UNITED STATES PATENT AND TRADEMARK OFFICE

10/518,596

Office Action Summary

DETAILED ACTION

FIG.1

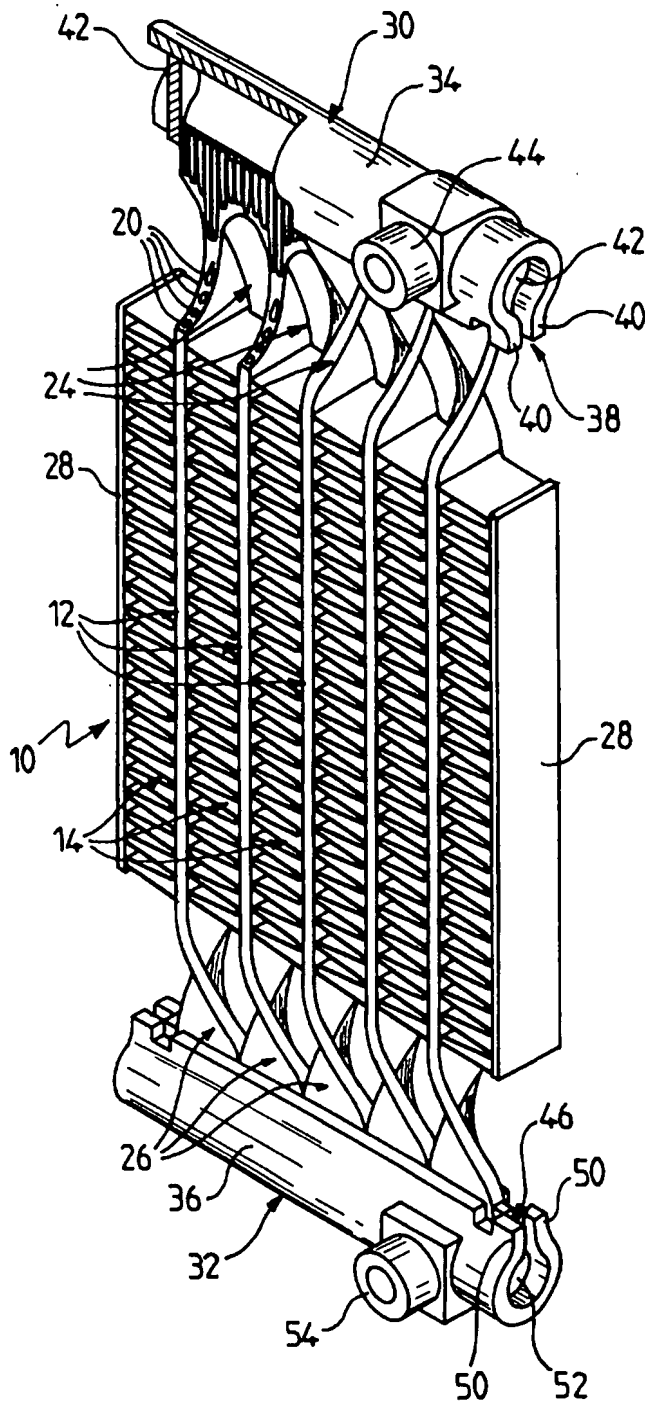
In regard to claim 6, Carlos teaches (Figure 1) that the number of first (24) and second flow connection sections (26) is equal to the number of tube sections (12).

In regard to claim 18-19, Carlos teaches that a plurality of distribution/collection spaces (30, 32) which are thermally separated from one another (Figure 1, 4); and the thermal separation is effected by a plurality of distribution/collection spaces (30, 32) being spaced apart from one another (Figure 1, 4).

In regard to claim 21, Carlos teaches (Figure 1) that the internal cross section of the receiving devices (24) substantially correspond to the external cross section of the through-flow device (12).

In regard to claim 24, Carlos teaches that the pluralities of through-flow devices (12; 56) are arranged substantially parallel to one another (Figures 1, 4; translated page 7, lines 12-14).

FIG.2

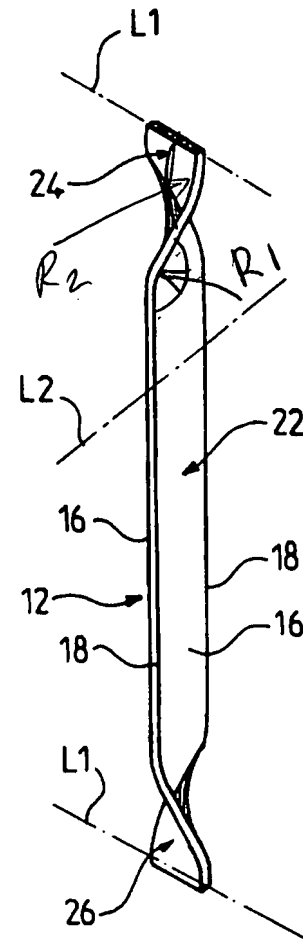
In regard to claims 12, Carlos teaches that the two transition sections (24, 26) are twisted in opposite twisting directions (Figure 2).

In regard to claim 22, Carlos teaches (Figure 2) that the receiving devices are substantially rectangular in form (24), and the longer side of these receiving devices is arranged at a predetermined angle with respect to the longitudinal direction of the distribution/collection device (30, 32; Figure 2).

FIG.3

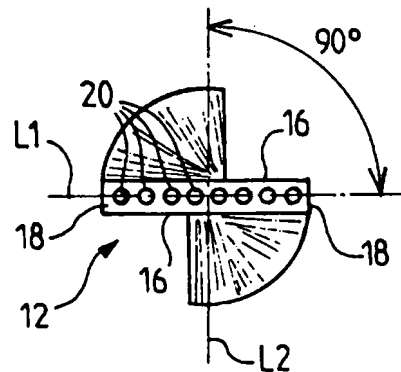
In regard to claim 23, Carlos teaches that the magnitude of the angle of the through-flow device is between 0° and 90° (Figures 2, 3).
